Access Compliance Report

Public Rights-of-Way

(Curb Ramps)

Intersection ID: 10021845	Main Street: BRIXHAM_HILL_AV	Cross Street: N/A	Location: NW
ADA ID: 5F5DCBBA2275	Ramp Type: Perp	Initial Pass/Fail: Fail	Overall Compliance: No
Severity Score: 12.5			
Codes/Mitigation Info/Possible Solution		Field Measurements/Component Compliance

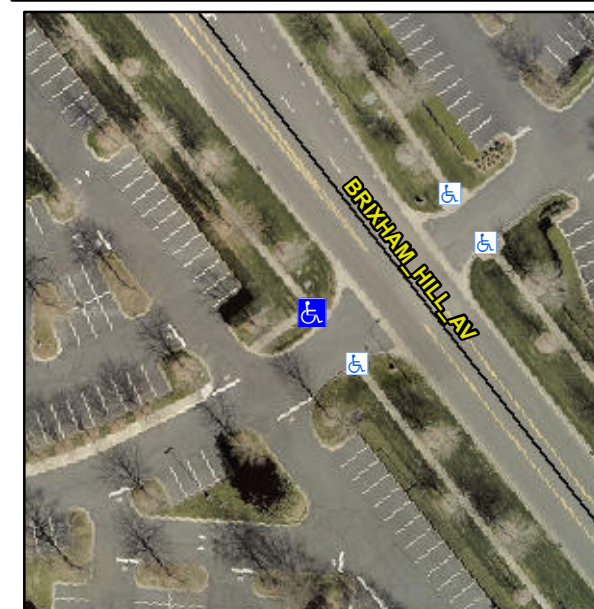
R304.5.3

Compliance	Description	Data	Compliance	Description	Data
N/A	Ramp Length (in)	72.0	Yes	Ramp Slope (%)	7.2
Yes	Ramp Width (in)	48.0	No	Ramp XSlope (%)	5.4
N/A	Flare Type LT	N/A	N/A	Flare Type RT	N/A
N/A	Flare Slope LT (%)	N/A	N/A	Flare Slope RT (%)	N/A
N/A	Flare Traversable LT?	N/A	N/A	Flare Traversable RT?	N/A
N/A	Landing Length (in)	N/A	N/A	DWS Provided?	N/A
N/A	Landing Width (in)	N/A	N/A	DWS Contrast?	N/A
N/A	Landing Slope (%)	N/A	N/A	DWS Length (in)	N/A
N/A	Landing X Slope (%)	N/A	N/A	DWS Full Width?	N/A
N/A	Landing Curb? (Y/N)	N/A	N/A	DWS Offset (in)	N/A
N/A	Shared Landing?	N/A			
N/A	Gutter Ponding?	N/A	N/A	Gutter Slope (%)	N/A
N/A	Gutter Lip Ht (in)	N/A	N/A	Gutter X Slope (%)	N/A
N/A	Painted X Walk1?	No	N/A	Painted X Walk2?	N/A
	X Walk 1 Direction	To SE		X Walk 2 Direction	N/A
N/A	X Walk 1 Width (in)	N/A	N/A	X Walk 2 Width (in)	N/A
	X Walk 1 Slope (%)	3.1		X Walk 2 Slope (%)	N/A
	X Walk 1 X Slope (%)	2.8		X Walk 2 X Slope (%)	N/A

Remove & Replace Entire Ramp.
